SERVICE BULLETIN # 1017A

SUBJECT Governor Vane Adjustment.

MODEL S44 - D44, 55, S55 DATE 4-3-58

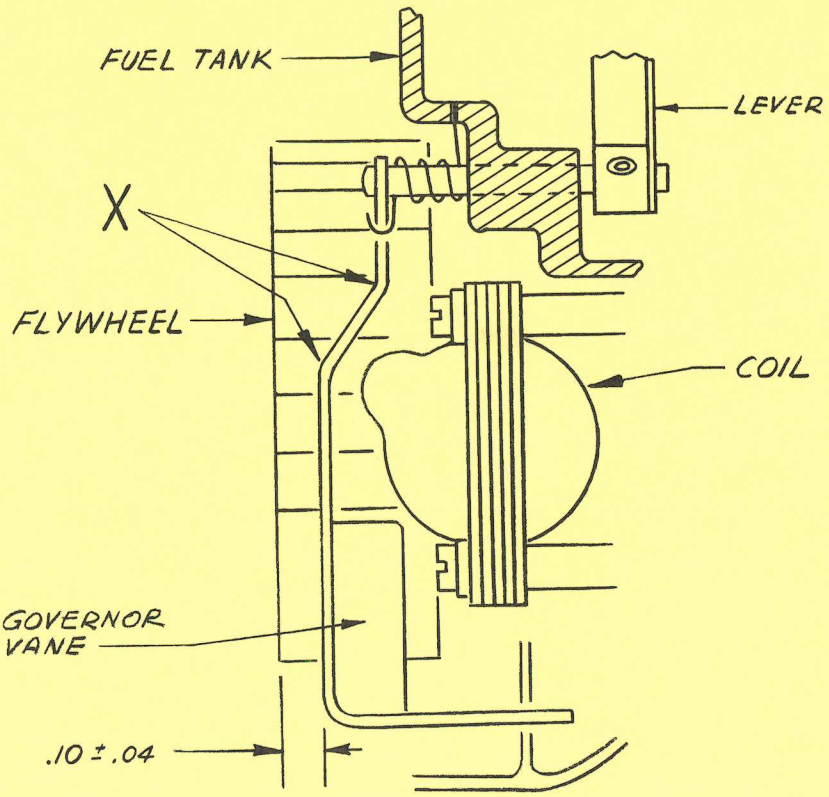
The position of the governor vane in relation to the flywheel fins determines the efficiency of air flow against the vanes. A direct flow of air is necessary in order to avoid erratic variation in governor action. As a result of extensive testing, a position has been established which will assure this direct flow of air.

The accompanying sketch indicates the correct governor vane position. If it is necessary, the position can be corrected by bending the governor arm at either of the points marked "X". Care should be taken that in the correct position, the coil or its mounting screws do not interfere with governor arm movement.
